**City of Portland, Maine - Building or Use Permit Application**

Permit No: 03-0961	Issue Date: OCT 16 2003	CBL: 021 D007001
-----------------------	----------------------------	---------------------

<b>Proposed Use:</b> Cathedral of The Immaculate Conception w/48" x 96" changeable copy Sign	<b>Proposed Project Description:</b> Install a 48" x 96" changeable copy Sign
---	--

(1) Changeable Lettering Sign  
 3/4" MDO Face  
 48 x 96

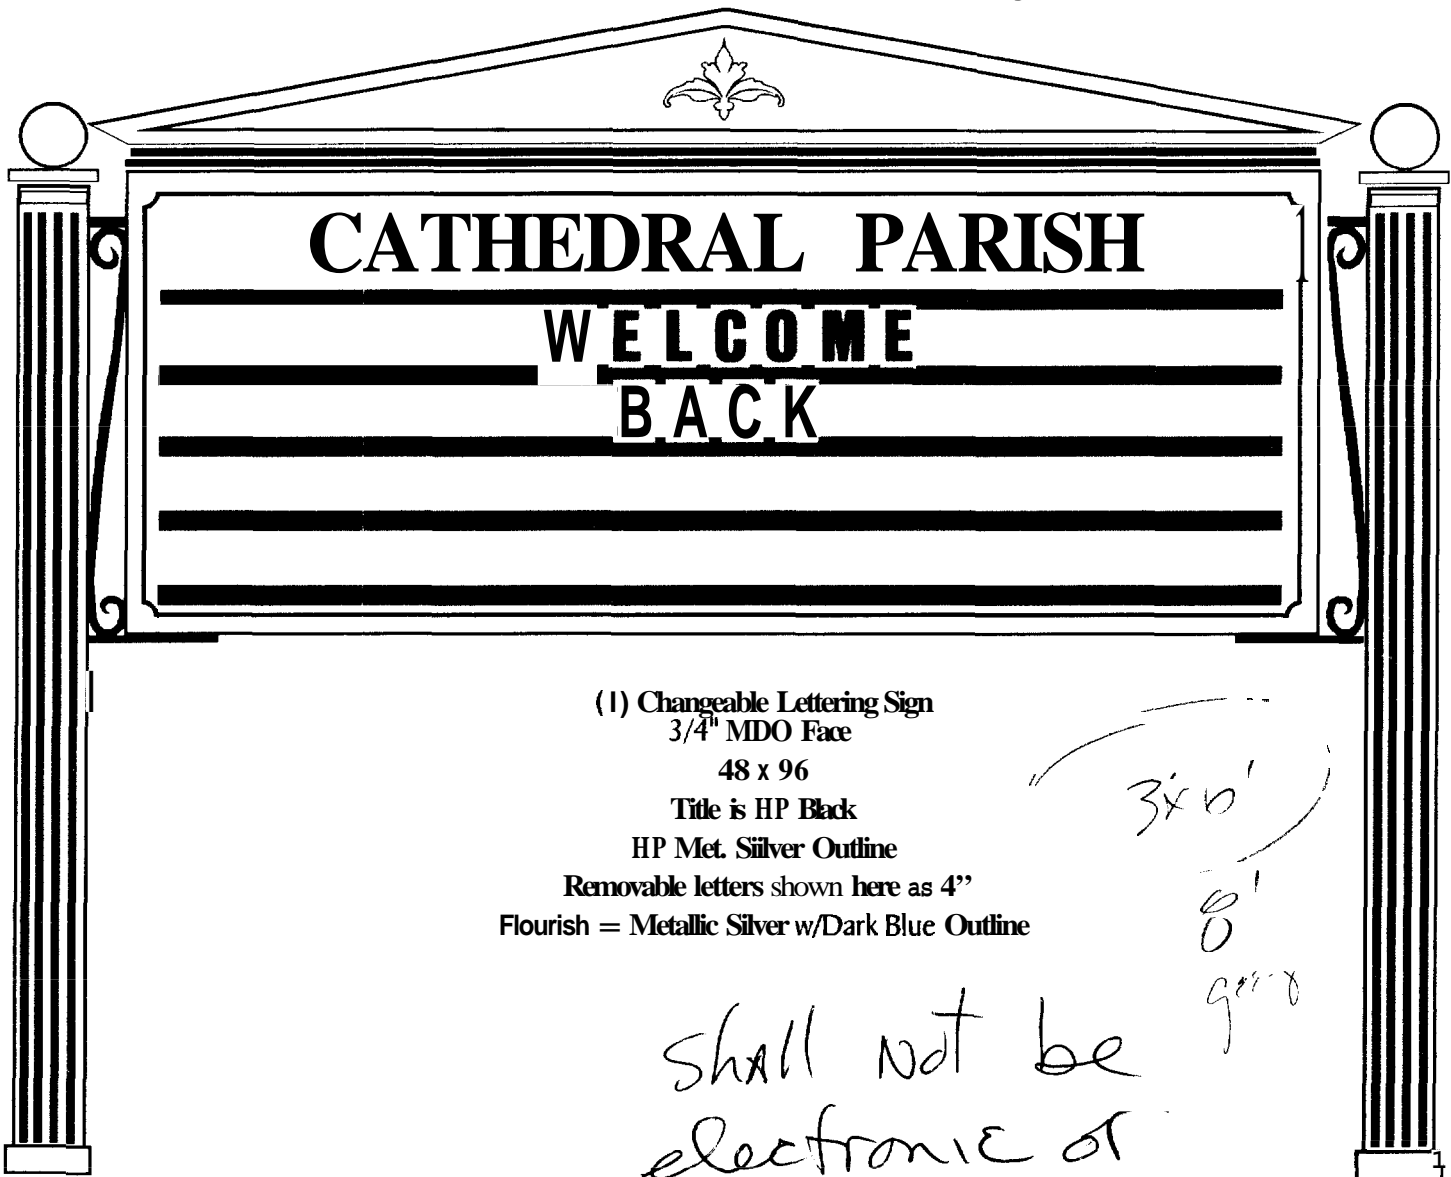
**Dept:** Historical      **Status:** Approved with Conditions      **Reviewer:** Deborah Andrews      **Approval Date:** 10/08/2003  
**Note:** Ok to Issue:   
 1) \* Approval is based on revised design and specifications (attached to original application).  
 \* Sign to be installed perpendicular to Congress Street.

**Dept:** Zoning      **Status:** Denied      **Reviewer:** Marge Schmuckal      **Approval Date:**  
**Note:** 09/08/2003 cannot approve for signage because does not meet current R-6 peninsula zoning - 14-368.5.g Ok to Issue:   
 allows further review and approvals for denied permits under 14-526(a)(23) - given to Deb A for review

shall not be  
 electronic or  
 scrolling

What is  
 in extra right  
 7
